Our Reference: NP26.022
TCC Reference: MCU26/0095
RB.MH

Response to Information Request
Development Application for Material Change of Use – Multiple Dwelling (3 Units)
42B Hughes Street, Hermit Park and formally described as Lot 2 on RP742182

Request Item 1 – Rearrangment of carports and driveway

2 SITE PLAN - PROPOSED
1 : 100

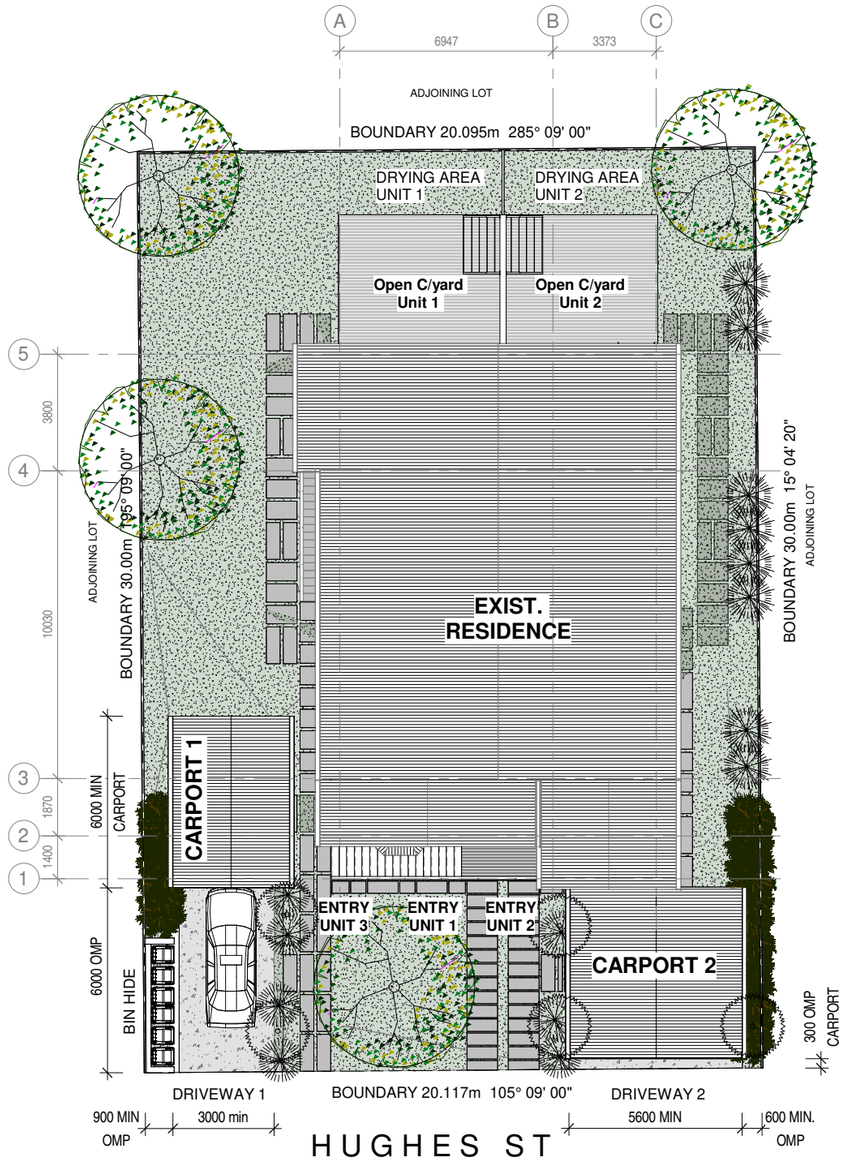
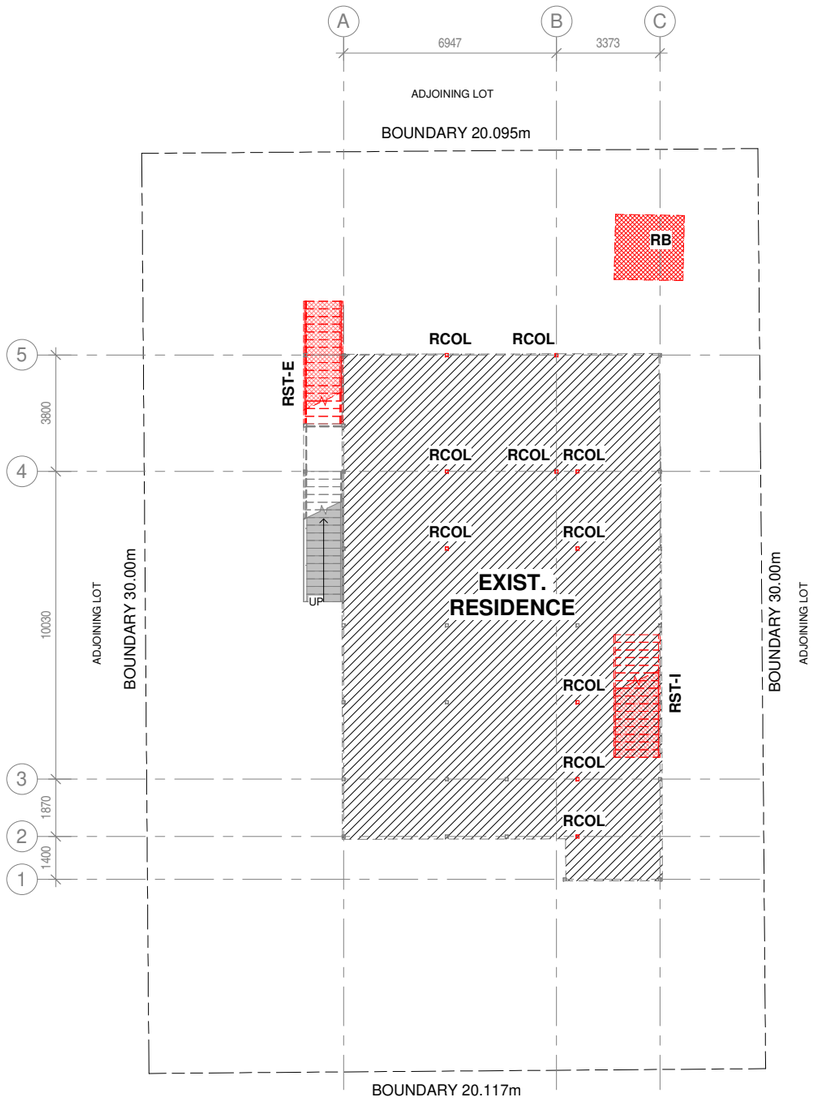
The applicant is requested to provide amended plans that removes Carport 1 from the frontage and relocates the covered parking to a tandem carport located along the eastern boundary and out of the front 6m setback. The site plan should also be redesigned to provide a double driveway access to Carport 2 accessed directly from the street and a single driveway on the east accessing Carport 1 from the street.

The applicant is advised that the current layout results in carports and hardstand driveway dominating the façade, the above requested design change will provide space for landscaping that will soften the development and assist in giving a house like appearance.

- Carport 1:
  - Relocated to the western side boundary as a single width carport, with a second tandem space on Driveway 1 directly in front of the carport.
  - Setback 6m from the Hughes Street frontage.
  - Accessed by a separate 3m wide driveway (Driveway 1) from Hughes Street.
  - Bin storage relocated to a screened bin enclosure on the western boundary, beside Driveway 1.
- Carport 2:
  - Reoriented to open directly to Hughes Street, accessed by a 5.6m wide double driveway (Driveway 2).

- Central driveway and manoeuvring area:
  - Removed and replaced with landscaping, including tree planting, and pedestrian paths to the unit entries.

The amended layout responds directly to Council's request. Relocating Carport 1 behind the front setback and removing the central driveway, substantially reducing the extent of hardstand and parking structures across the frontage. This area is now provided as opportunity for additional landscaping, resulting in the building entries, rather than parking, being the dominant elements when viewed from Hughes Street.
